# **SUBMISSION**

# DRAFT STATE ENVIRONMENTAL PLANNING POLICY (Major Projects) -AMENDMENT (REDFERN-WATERLOO) 2006

# DRAFT REDFERN WATERLOO BUILT ENVIRONMENT PLAN 2006

# ABORIGINAL HOUSING COMPANY

Fig 2 - Source: NSW Government - Redfern Waterloo Authority - Draft Redfern Waterloo Built Environment Plan

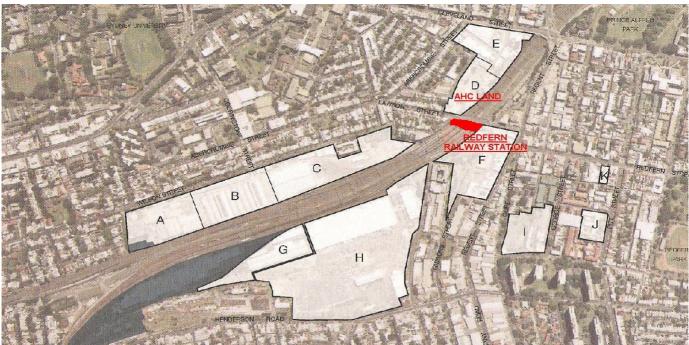
The draft BEP claims that it has been prepared to be consistent with the Metropolitan Strategy, but in relation to the AHC's land that is an unfortunate and incorrect claim. Compared to the other Sectors in the Plan, the AHC and the other property owners in "Area D" have been very poorly treated without any explanation. There is no planning justification for the resulting lower residential density controls.

The planning for Sector Z is not consistent with the provisions of the Metropolitan Strategy in that the SEPP does not maximize residential opportunities adjacent to a transport node, refer to Fig 2. In contrast to Sector Z the SEPP does maximize development opportunity (for residential and business) in the other 3 sectors around the transport node.
